RECEIPT DATE: 7-29-19 **ONSITE SEWAGE DISPOSAL SYSTEM** P 965575

RE: 2385 Rt. 97
Cooksville, MD 21723
"Septic Plan Comments"

**SEPTIC SYSTEM INSTALLATION SITE PLAN**  
**2385 MARYLAND ROUTE 97**  
 ZONED: RC-DEO  
 TAX MAP 14 GRID 11 PARCEL 253  
 FOURTH ELECTION DISTRICT HOWARD COUNTY, MARYLAND  
 SCALE: 1" = 40' DATE: OCTOBER, 2018  
 SHEET 1 OF 1

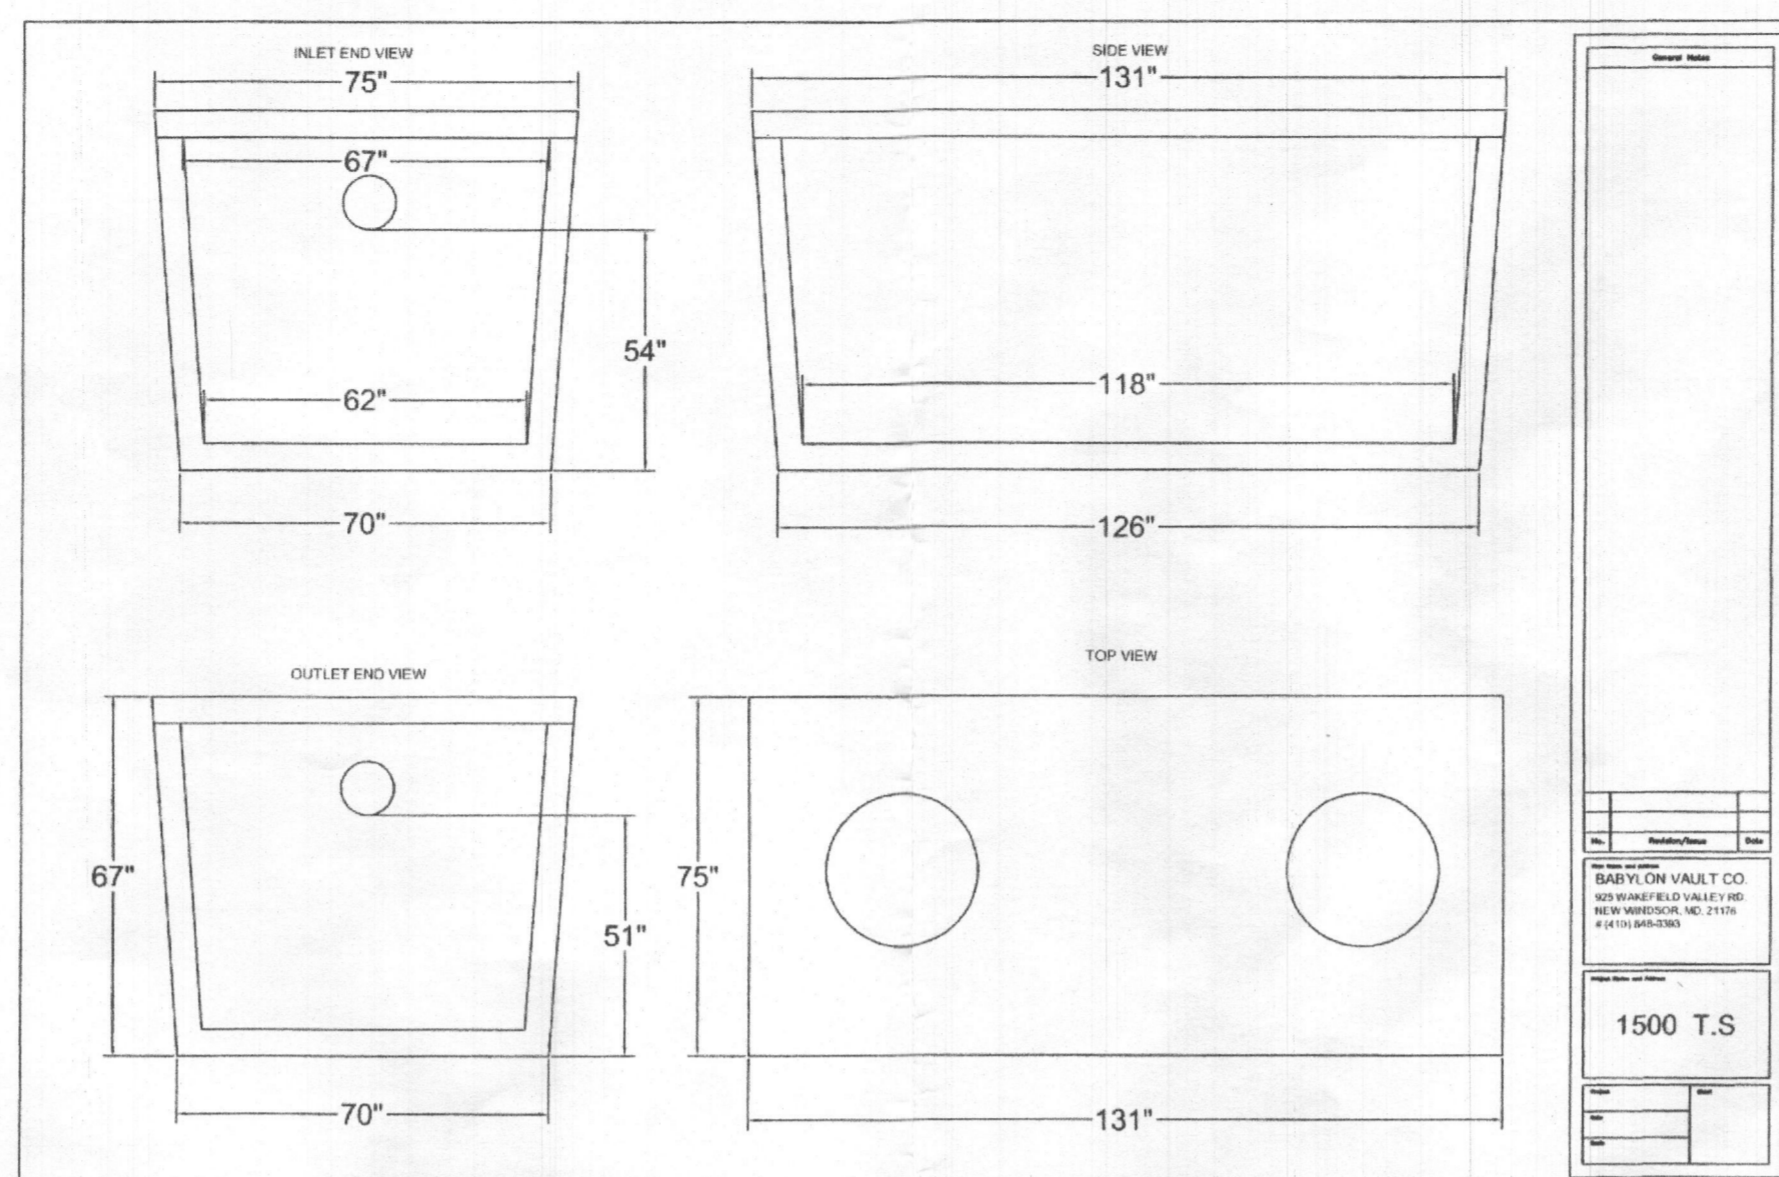
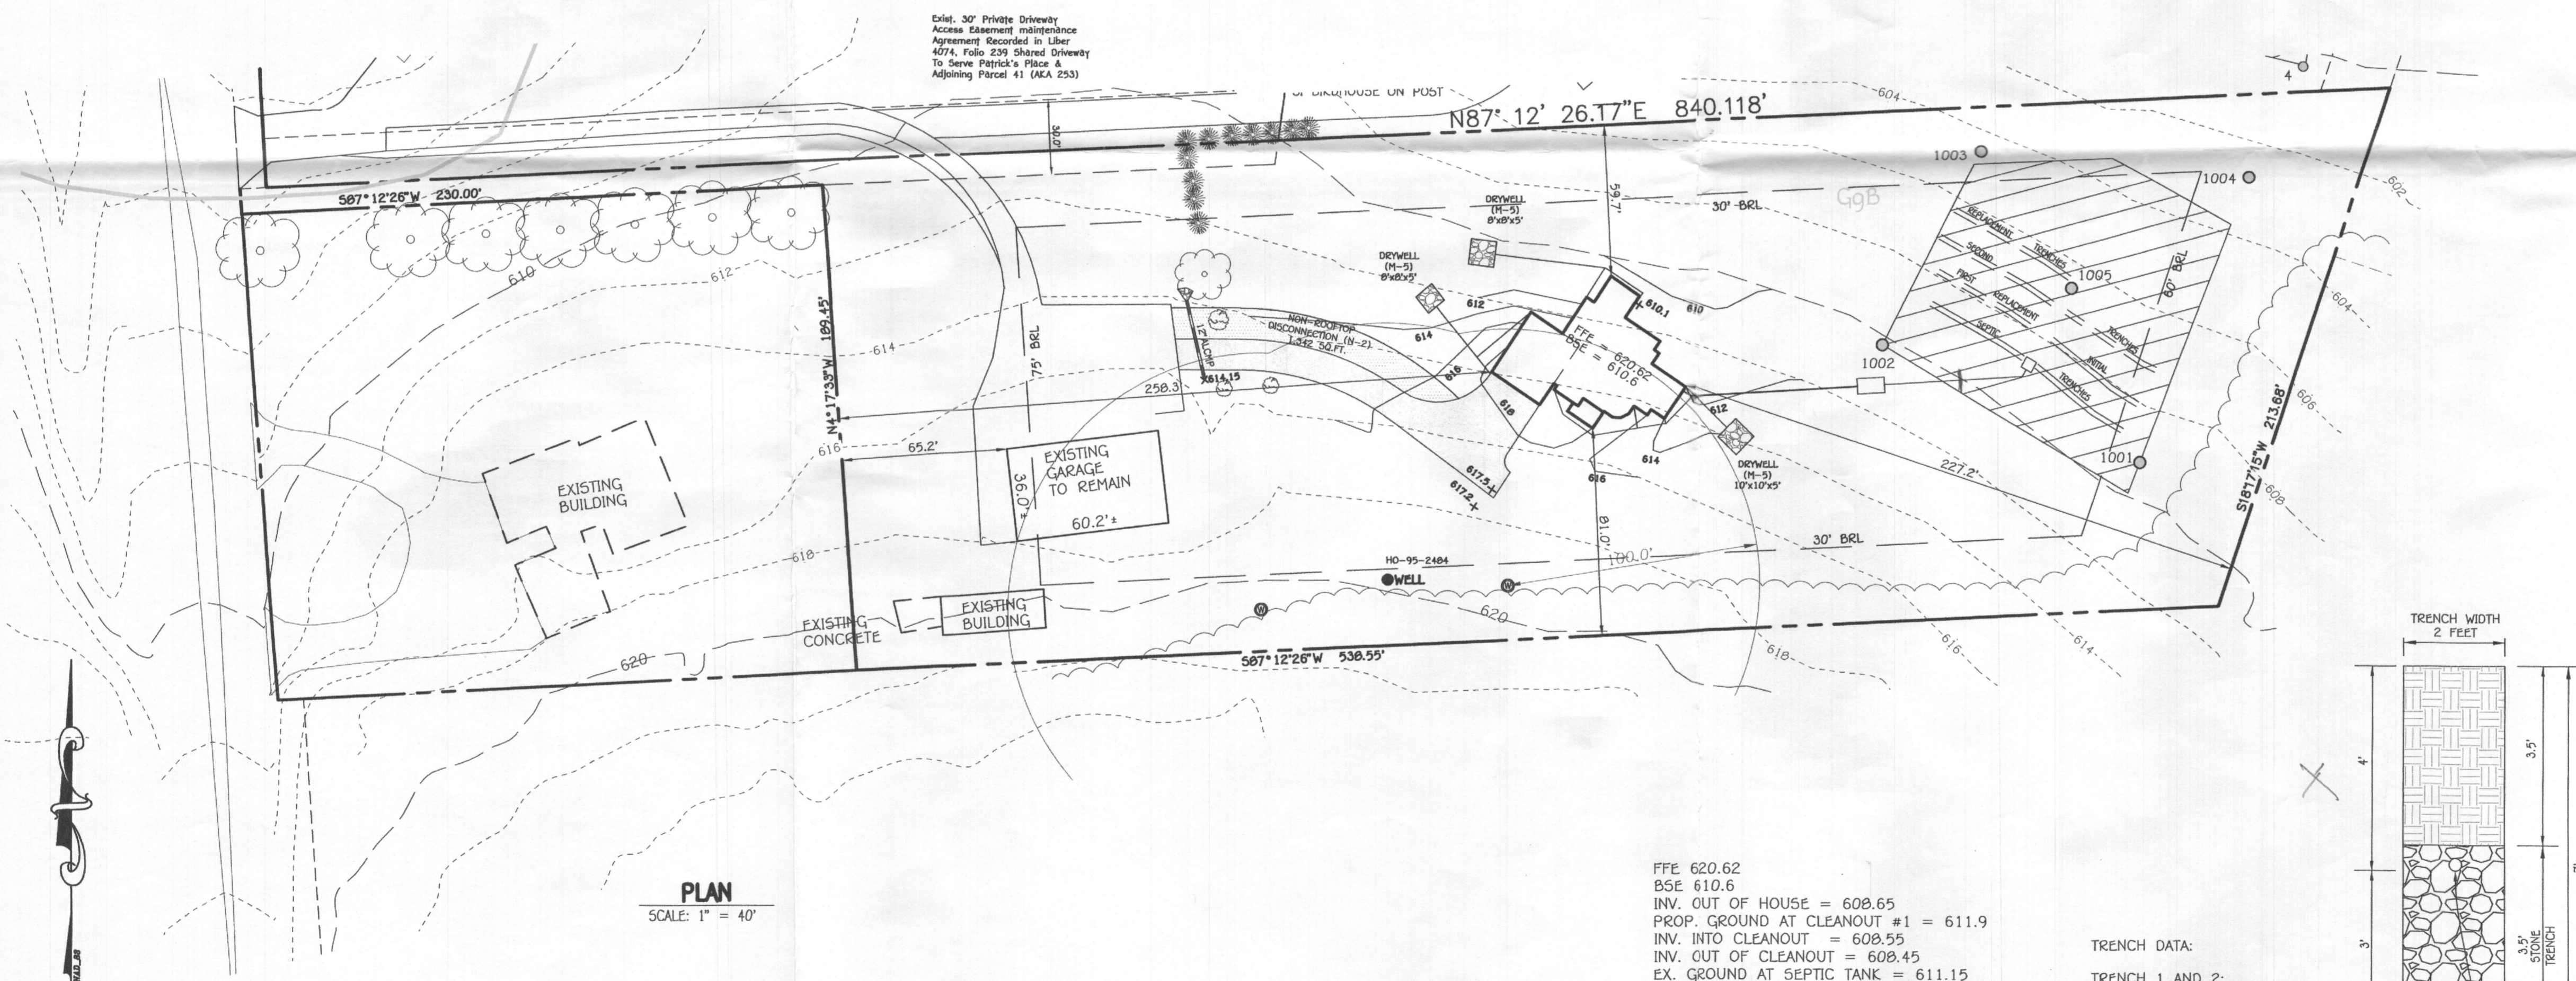
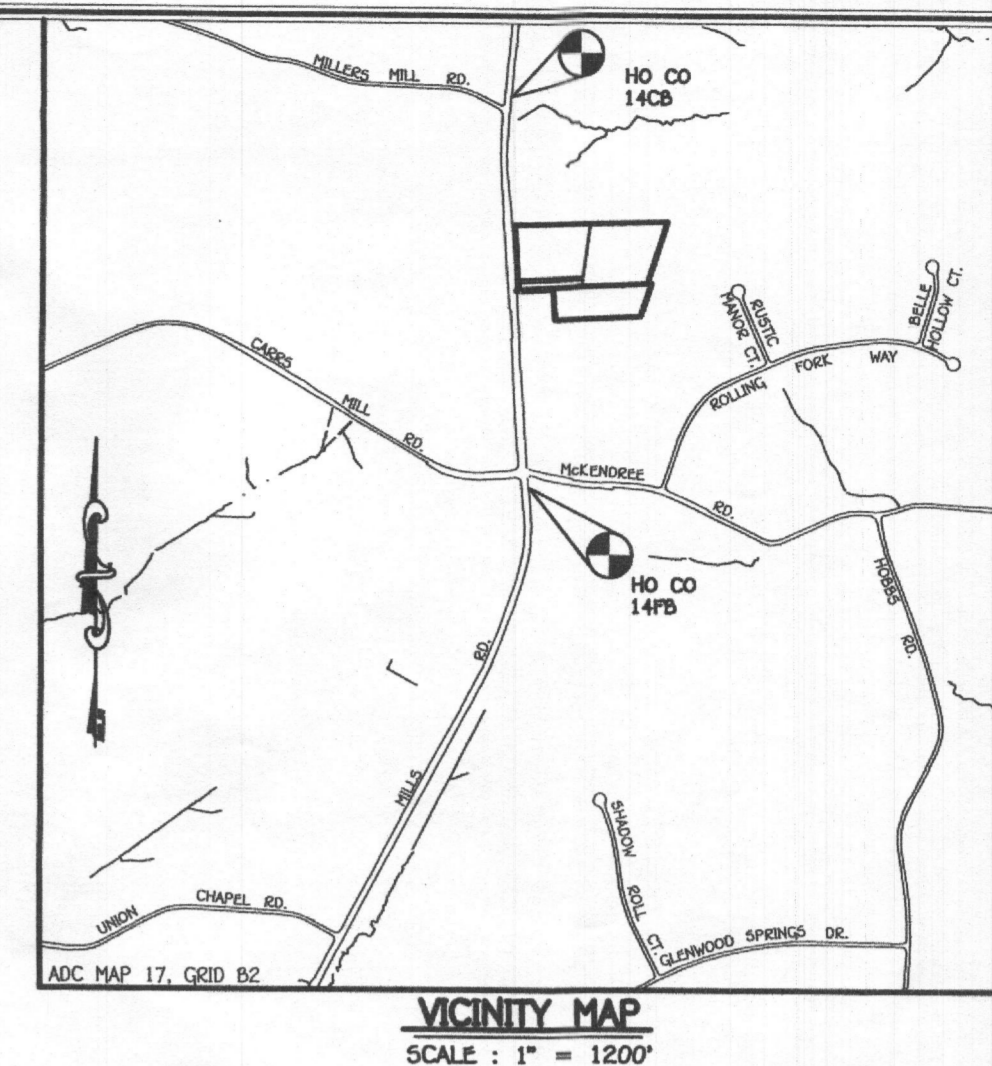
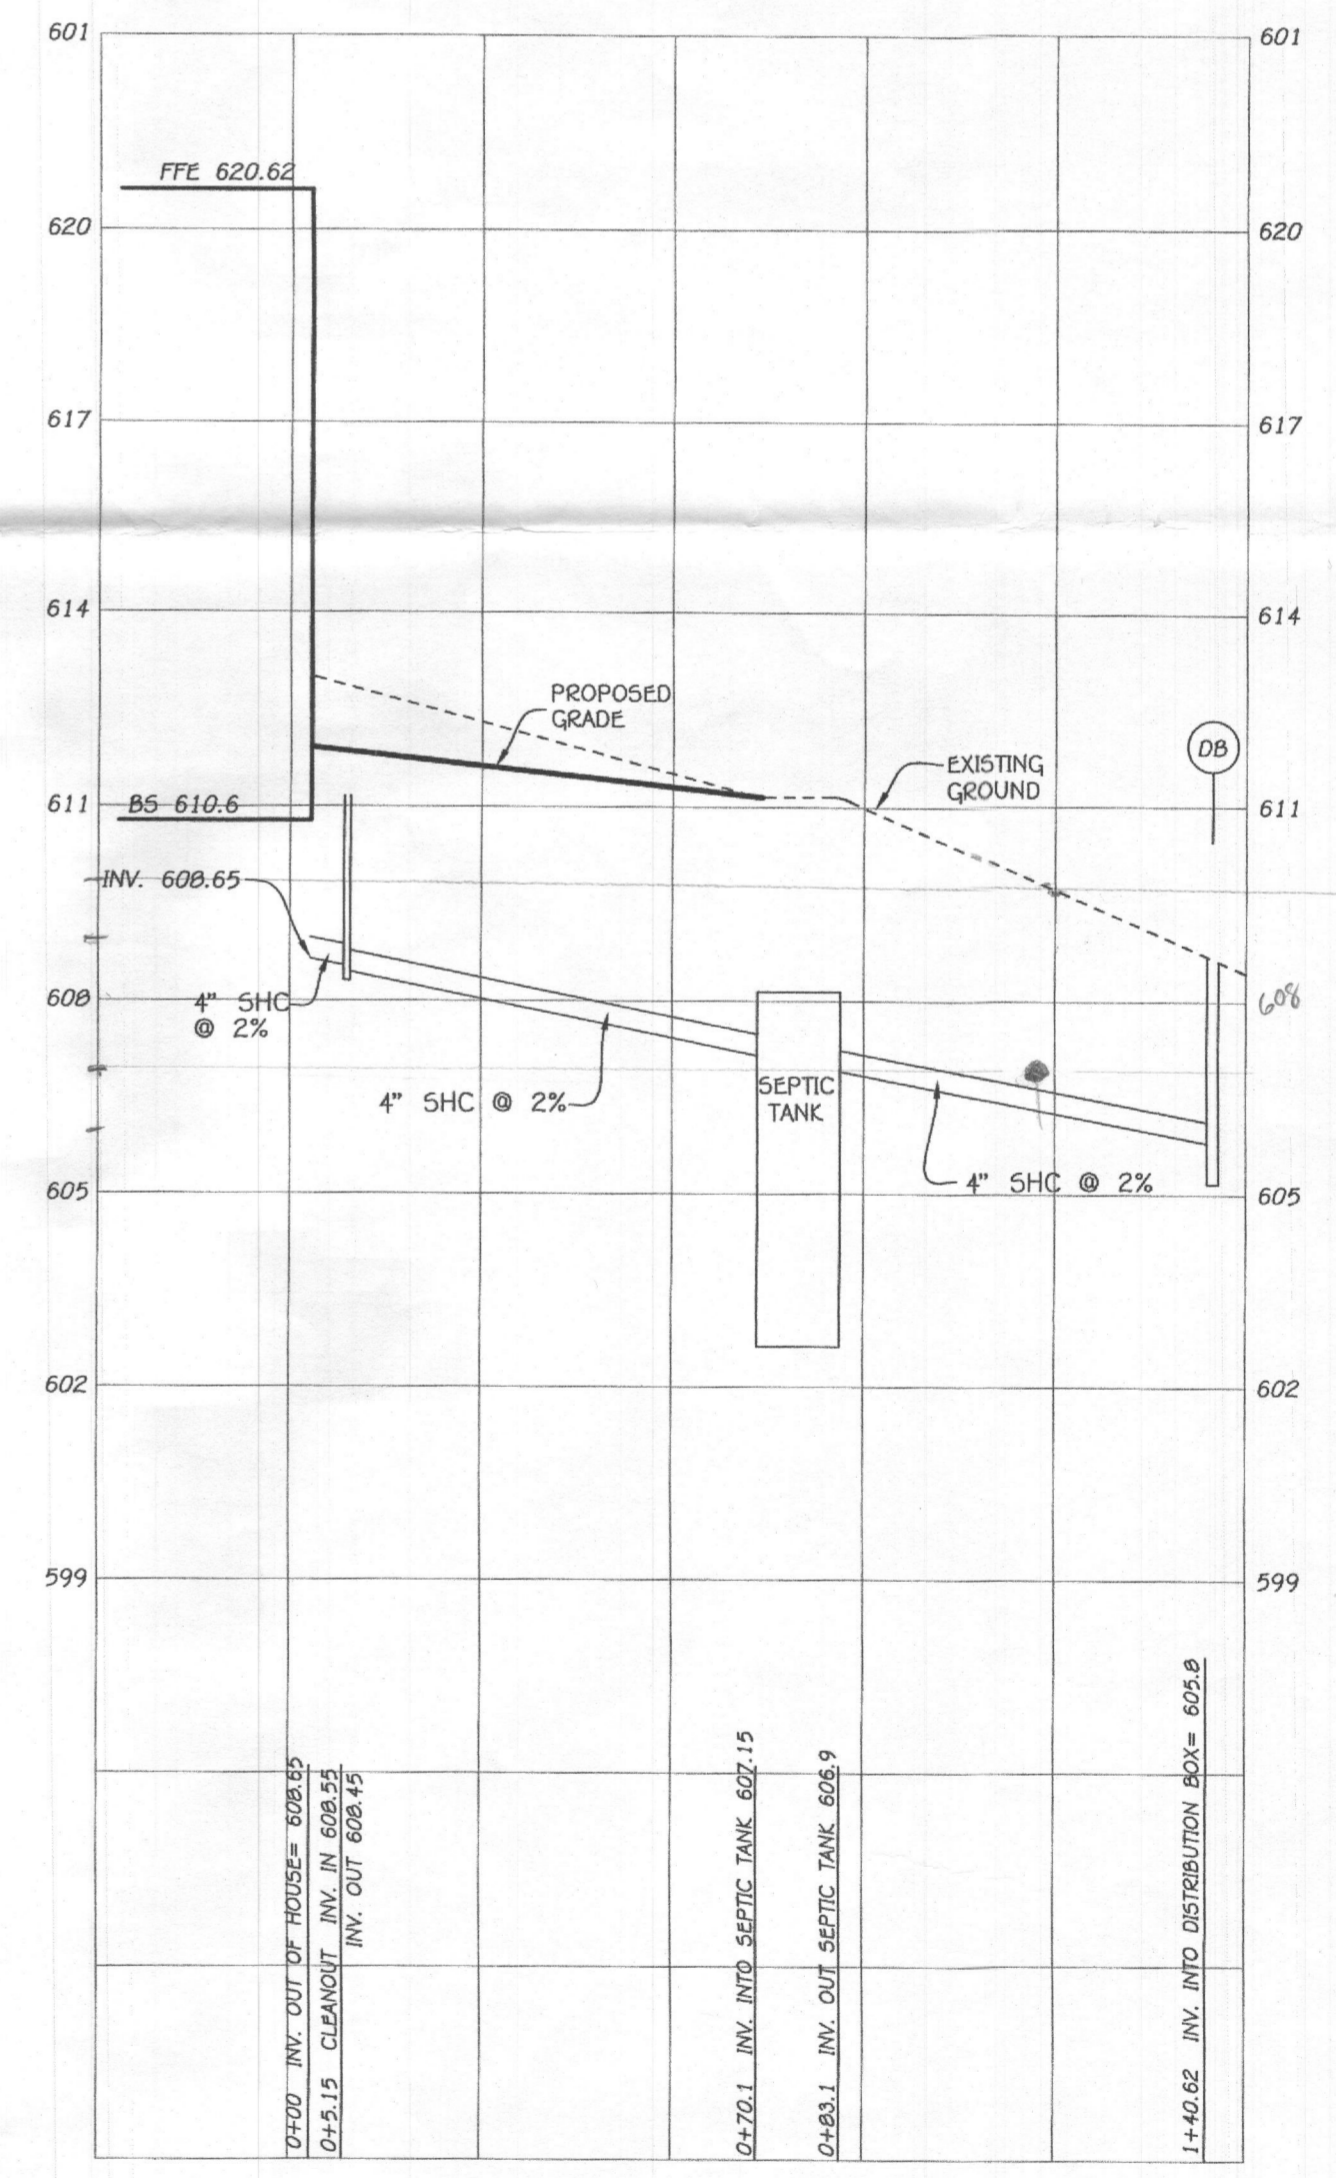
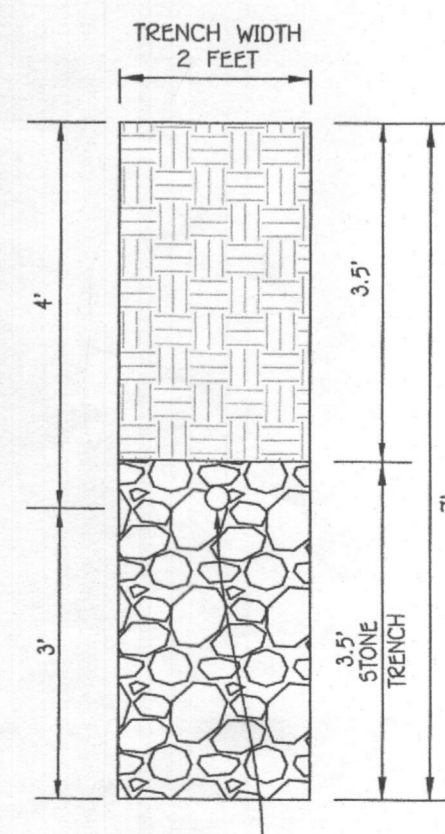
- Septic tank must be a two chamber tank. Center wall must have a slot 2 inches in height and 4 feet wide for the effluent to flow through. This center wall should split the tank in to a 2/3rds section and a 1/3rd section.
Label all existing structures on the property along with "To Remain" or "To Be Removed".
Alternate well sites must be visible. Symbol representing the existing well should be used to show the existing well on the "Plan".
Clearly label trenches as to which are the initial and which are replacements. Whole trenches should be shown as whole trenches. Showing sections of a trench that is actually whole will be confusing.
There are more trenches shown on the "Plan" than are described in the system calculations.
Put the well tag number next to the existing well.
Shown the sqft of the SDA.
Pull the trenching systems south up to the edge of the SDA. The space between the SDA edge and proposed trenches is being wasted.

"Plan" needs to clearly show which line is the septic line and which line is the drywell line at the eastern most corner of the house. It is hard to tell which line is which.
Make sure each section of the septic plan (Plan, Initial Trench Detail and Septic Profile) correspond with one another. There are multiple differences in elevations between the three.

Remove Note 3

- Labelled existing on the plan
- Trench detail is to be removed
